13074 28 August 2013

SECTION 75W MODIFICATION APPLICATION TO MP 09_0007 STAGE 1 MOORE THEOLOGICAL COLLEGE RESOURCE AND RESEARCH BUILDING

Figure 2 – Approved and Proposed Resource and Research Centre from City Road

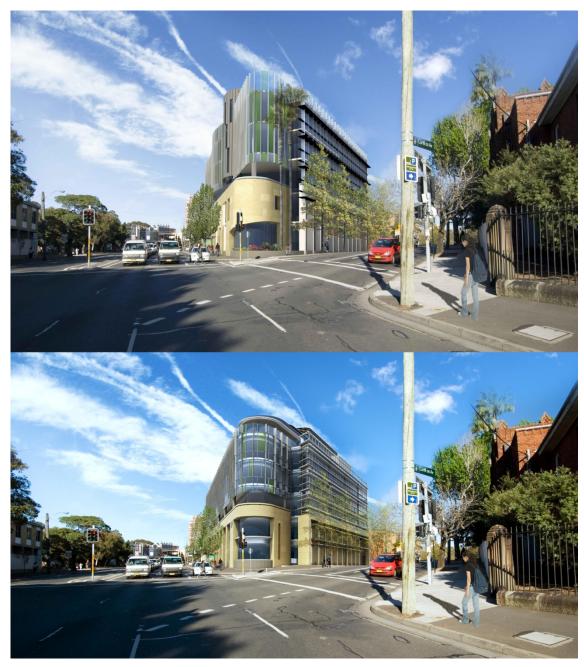
The proposed modifications will not have any material impact on the approved built form and will not result in any increase in height or scale of the building. The approved and proposed comparison perspectives at **Figures 2-4** illustrate that the modifications will still achieve a high quality built form outcome consistent with the approved building.

As part of the detailed design phase it became apparent that the roof top plant room provided as part of the approved project was undersized and would not be able to accommodate the quantum of plant required to service the building. Accordingly, it is proposed to increase the area of the rooftop plant room, noting that it does not increase the approved height and continues to comply with the maximum approved height under the Concept Plan. It is noted that

The additional plant area will increase the bulk of the top level when viewed from certain angles. As illustrated in **Figures 2-4**, the plant room is only partially visible and will read as part of the building and when viewed from City Road but will become more prominent when viewed from certain locations on King Street. Despite becoming more prominent, the plant room is adequately setback so that it does not contribute to the bulk or scale of the building. The shadow diagrams included at **Attachment A**, illustrate that the plant room will not result in any discernible additional overshadowing, and in some cases the modified design will reduce the shadow cast by the development.
